DPEMP Supplement – Compost production Brightsides, Plenty Valley Road (DA 162-09)

Key issues

Specific comments

Figure 7a. Property ID 5829416, Title Reference 126321/2. The property will be owned by Tim Jenkins.

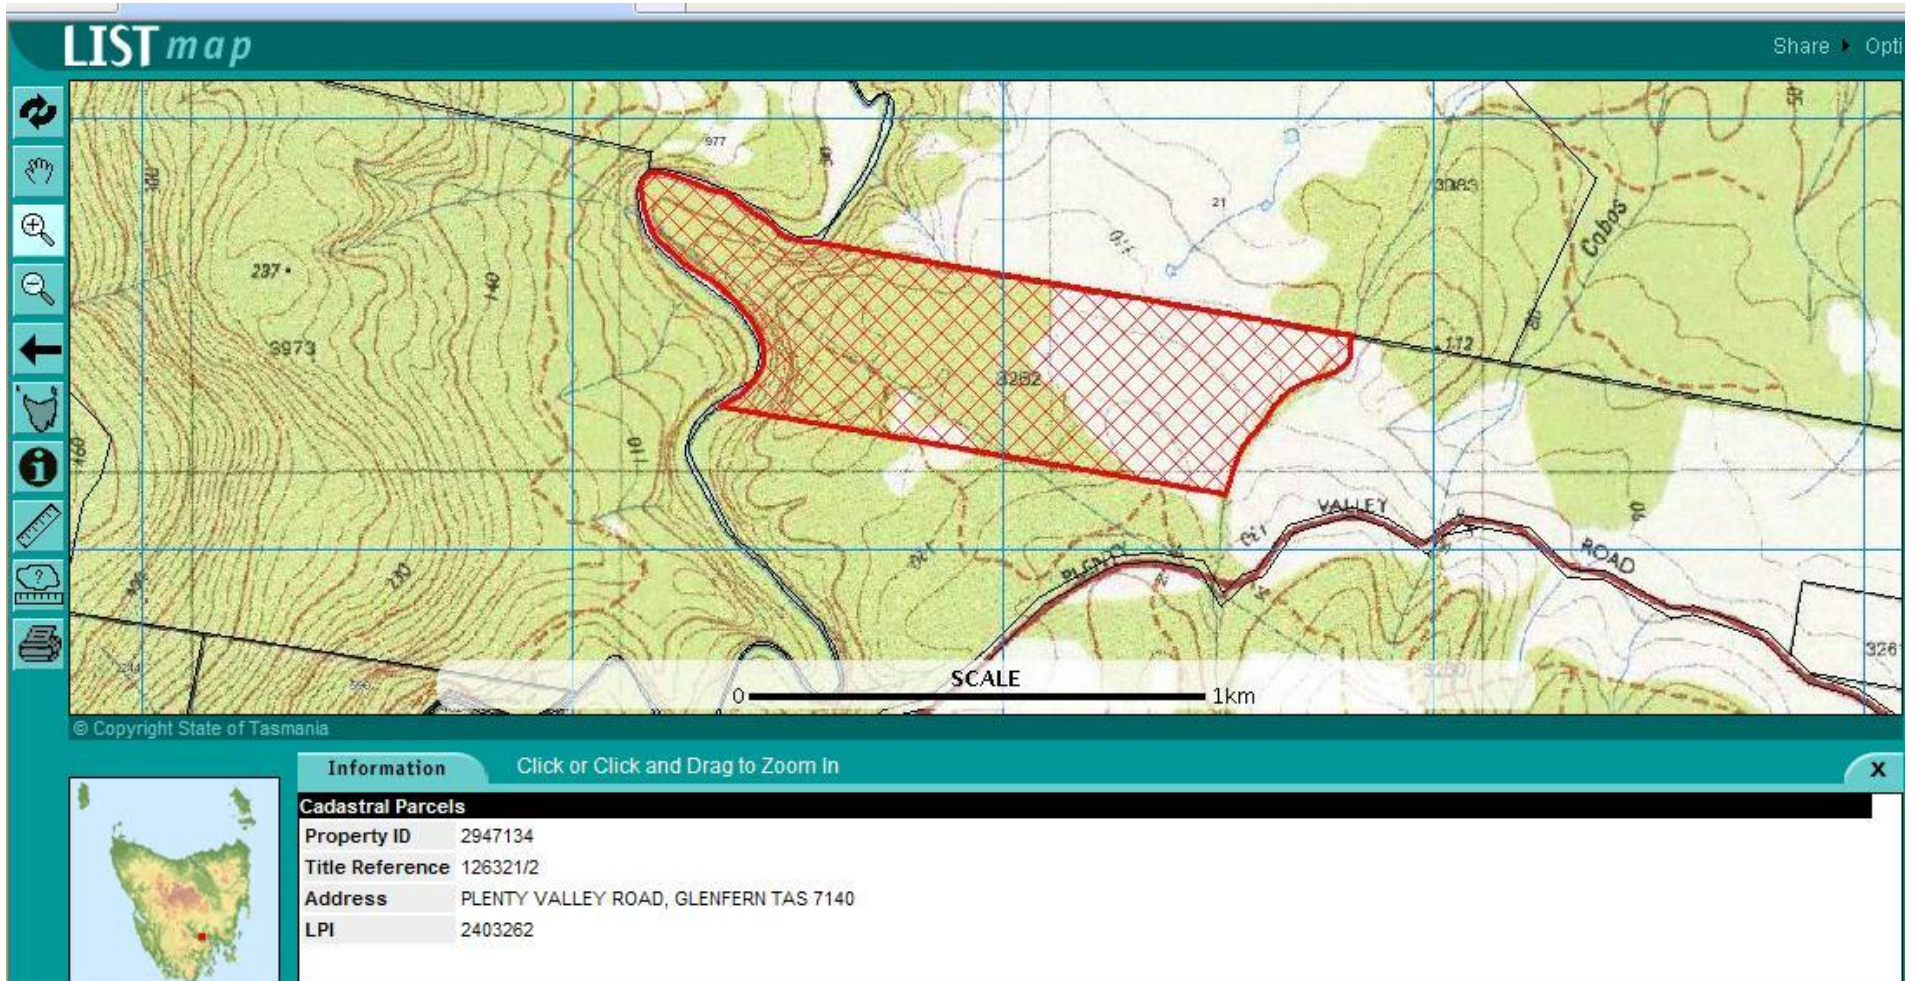
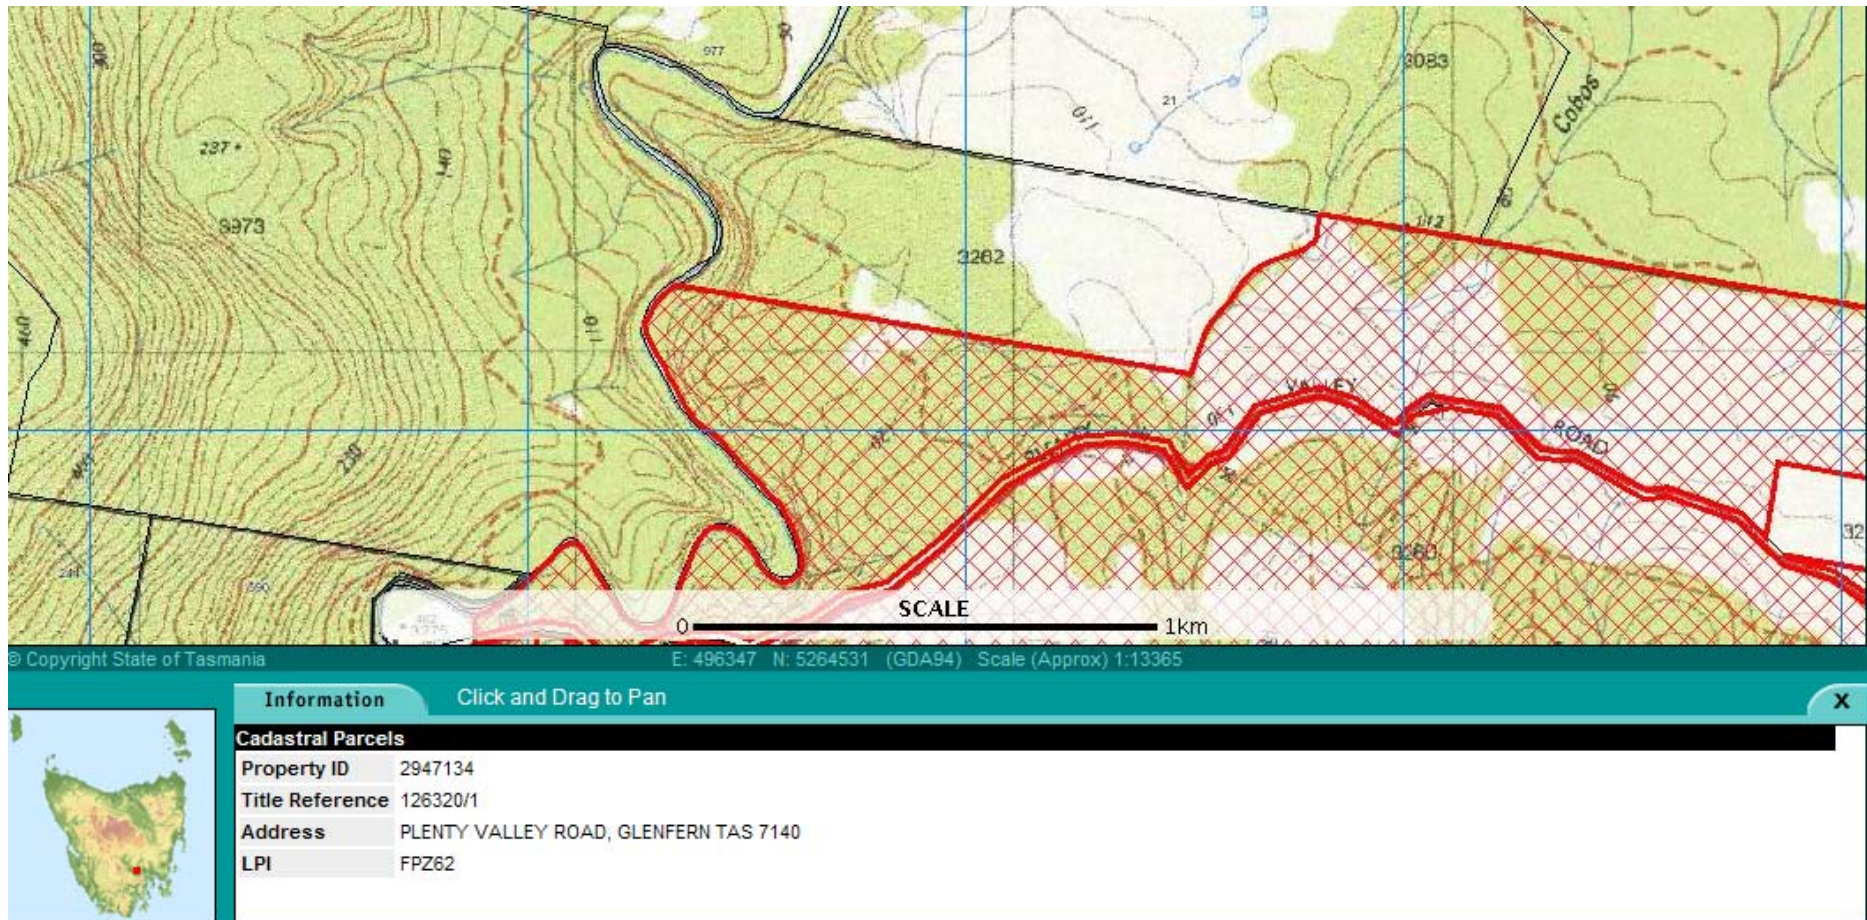
Page 37: Location map shows the composting site straddling two titles. They are apparently in the same ownership but a copy of the second title is required.

Figure 7b. Property ID 5829416, Title Reference 126320/1. The property will be owned by Tim Jenkins.

LOCALITY PLAN 1:10000

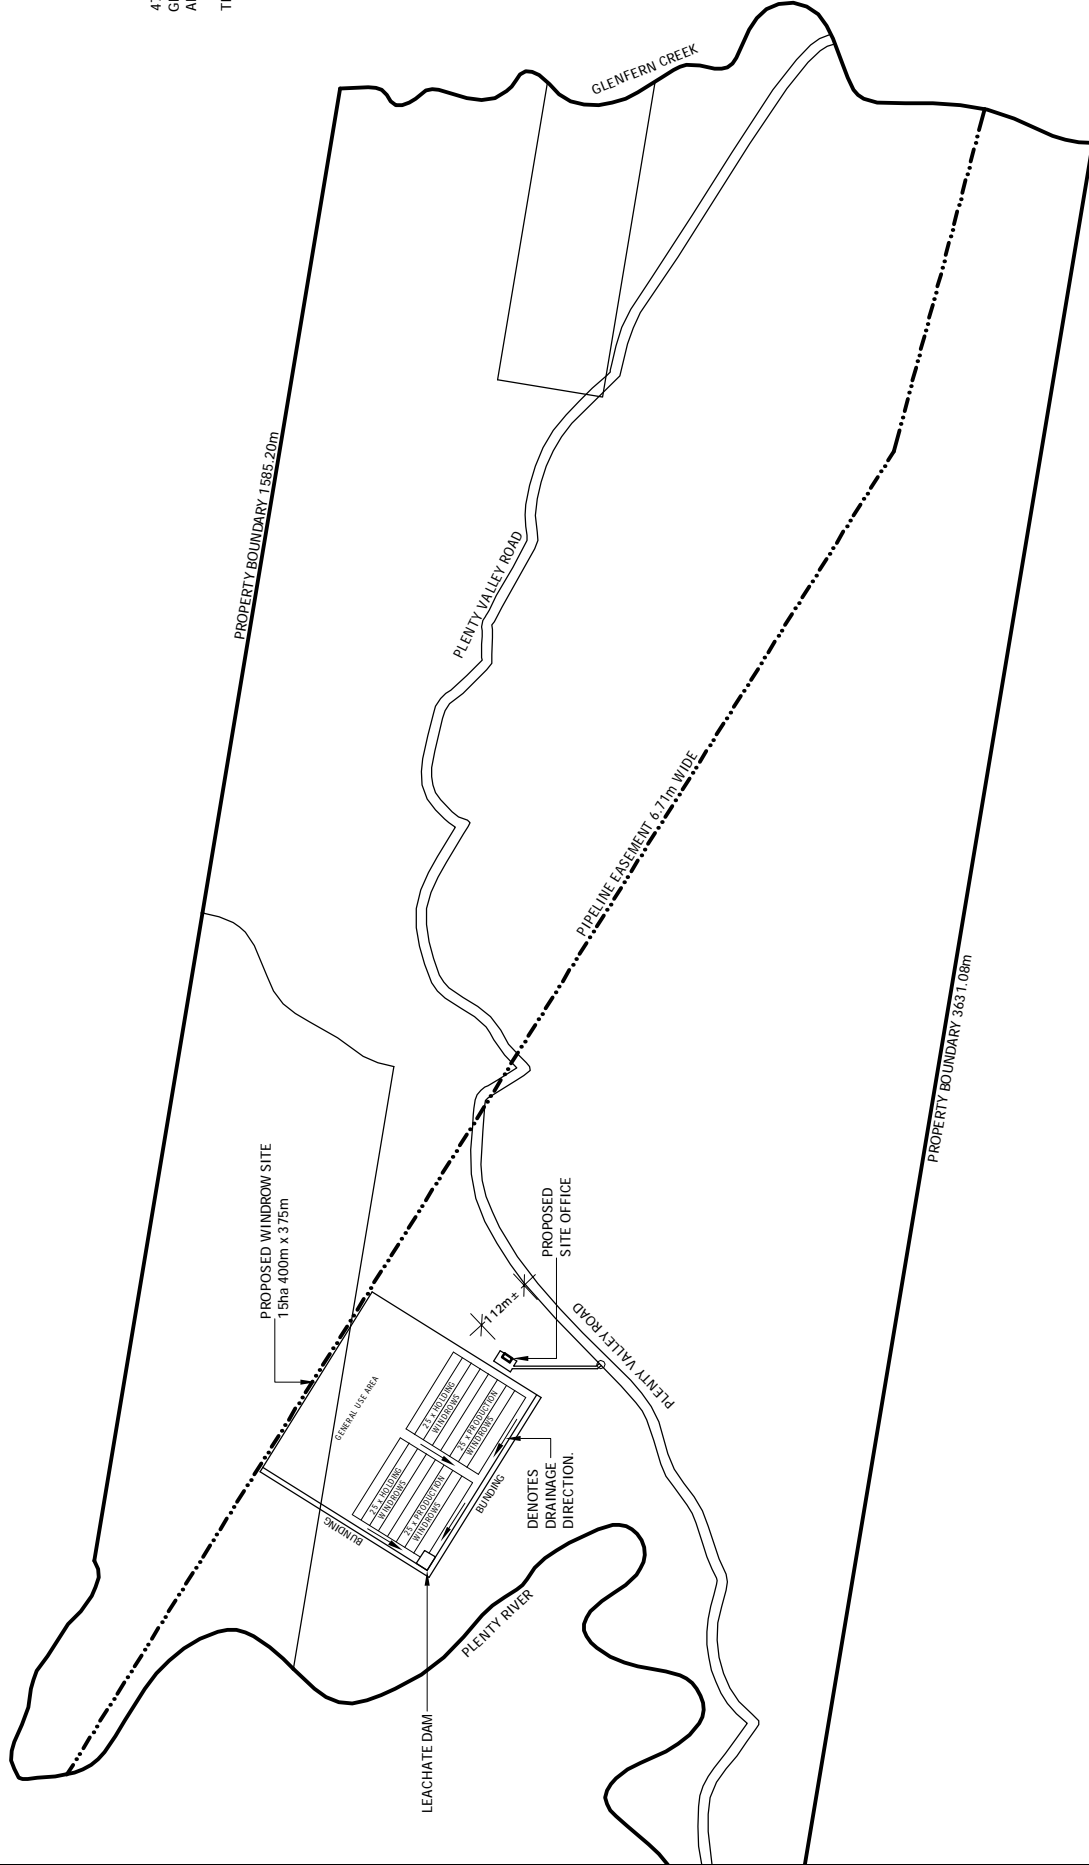
- 1) The major omission from the DPEMP is a satisfactory water balance.
- 2) A plan should be provided showing the location of windrows, the areas to be compacted, the shed containing the ACE production facility, the bunds and the leachate dam.

Page 48: *Provide greater detail of the construction and layout of the “hardstand” which will underlie the compost windrows. Clarify whether the entire site will be compacted or just the footprints of the windrows. Clarify how the 0.3 m compacted clay will be achieved.*

A detailed site plan is attached (Attachment 2). The compacted area will be 85,500 m² below the compost production and holding areas. The remaining area within the compost site will be for general agricultural use. The ACE production tanks will be inside the machinery shed.

Attachment 2 illustrates the compost holding and production areas and the leachate dam. The ground beneath the compost holding and production area will be compacted. The top soil will be removed as per Appendix K (Soil permeability calculations) in the DPMP and compacted ground will be achieved with a single or twin drum roller. Gravel will also be placed on top of the clay.
